ASUW Shell House

SEATTLE LANDMARKS PRESERVATION BOARD
Briefing Packet #3 - May 2025

UW ASUW SHELL HOUSE - PROJECT #DONH-COA-01340

SECTION PERSPECTIVE - PROPOSED NEW ELEMENTS

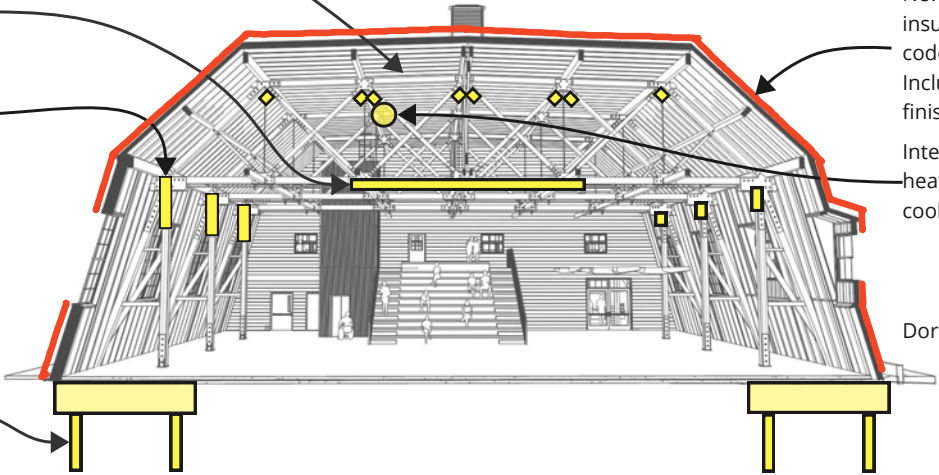
Mr. Jones provided an overview of the truss strengthening approach and said they are working with a structural engineer to determine the actual sizes required.

Ms. Chang said she supported strengthening the trusses. She said so many buildings have been seismically retrofitted that the public is used to seeing it. She said over time materials degrade and connections weaken a bit. She supported putting the louvers in the windows and noted she didn't want new penetrations in the façade.

Add rods and plates at
damaged or failing
bottom chord of truss

Seismic upgrade of all
truss connections

Wall Section - Proposed

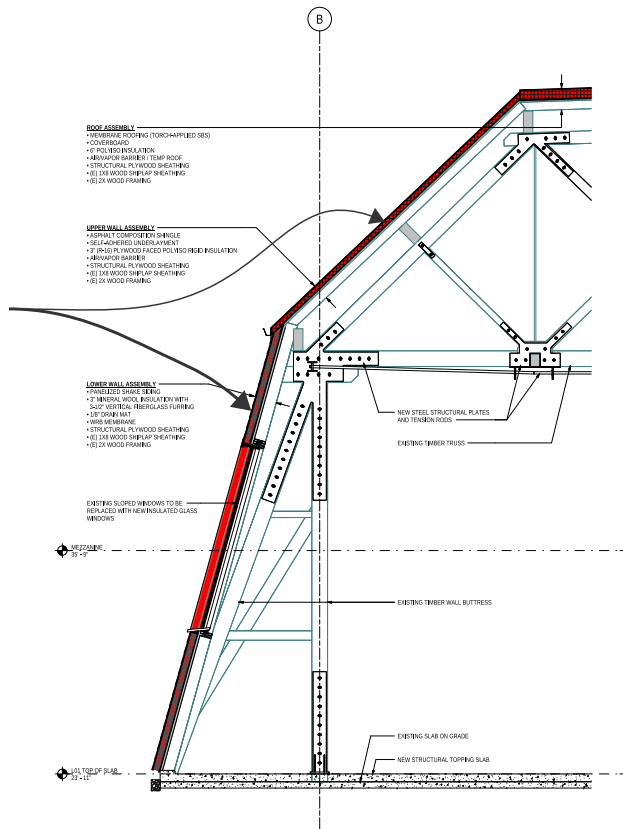
Ms. Doherty said the proposal to put the insulation outboard of the building envelope rather than inside is an unconventional approach. She said the team has done a good job of explaining why they want to approach it that way and showed that they are going to try to minimize the thickness of that. She said it is an important issue and the board should offer feedback.

Mr. Macleod said putting the insulation on the outside of the envelope is a more involved process. He said he agreed with the intent of preserving the experience for the inside of the shell house and he appreciated how the exterior insulation is being pursued as an option. He said it is important to listen to the stakeholders on this project and while he may not understand their concerns, he said it is important for the design team to.

Ms. Wasserman agreed that people working on this project should be aware and consider stakeholder comments. She said she likes the idea of putting the insulation on the outside of the building as it preserves the interior experience.

New structural sheathing, insulation and claddings to be added to the exterior of the building

Existing structure to remain exposed

North Facade Louvers - Previous Options

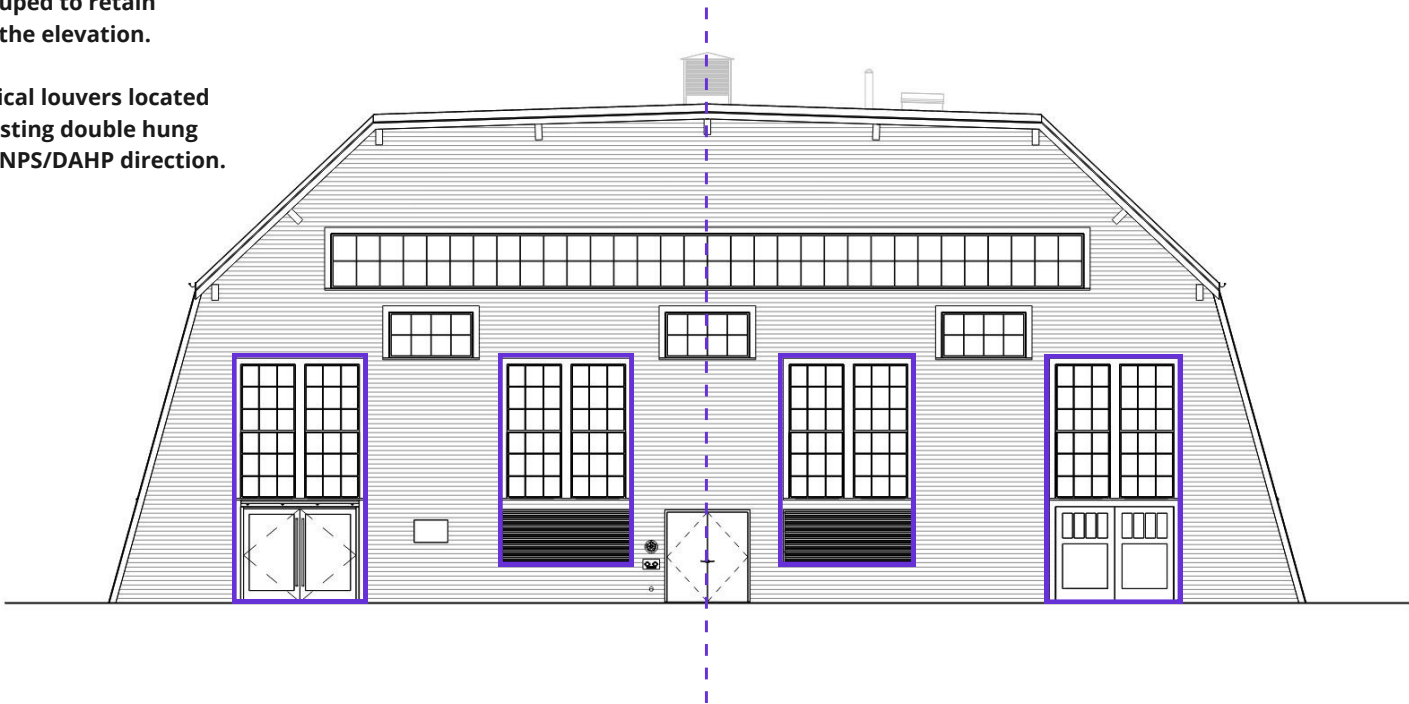
Ms. Randall supported the preferred option for the glazing as it best hearkens to the past uses as shell house, hangar, etc. She preferred the louver option that uses the existing window frames which she said was preferable to creating new voids in the façade. She asked about siding choice.

Mr. Jones explained that a gender-neutral bathroom sits behind the windows on the north façade so putting louvers within the windows will hide the partition wall.

Mr. Macleod said he supported louvers within the window frames and no further penetrations in the façade.

- Openings grouped to retain symmetry of the elevation.
- New mechanical louvers located below the existing double hung windows per NPS/DAHP direction.

South Elevation

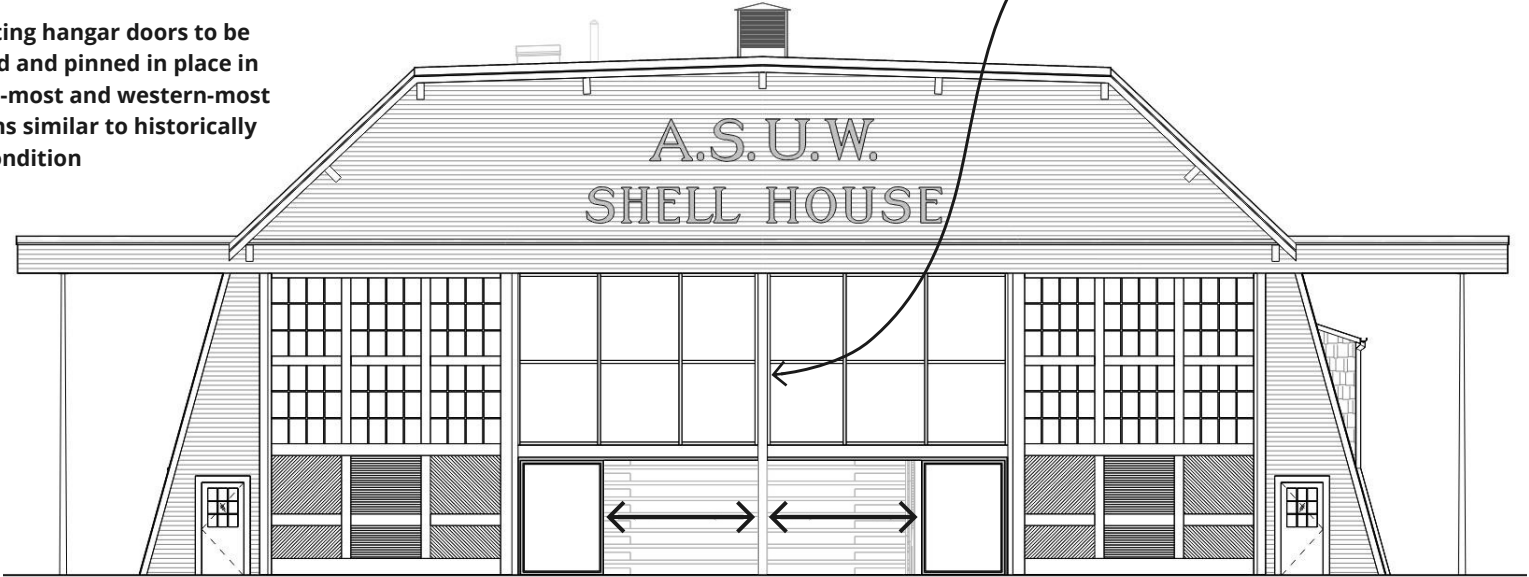
Ms. Wasserman preferred the third door option. She appreciated the access to outside.

Ms. Chang preferred the third option. She said it provides the most access to the outside. She said the design is headed in the right direction.

- Central glazed opening to visually connect interior and exterior year-round.
- (2) existing hangar doors to be restored and pinned in place in eastern-most and western-most positions similar to historically open condition

Existing center column replaced with painted steel column
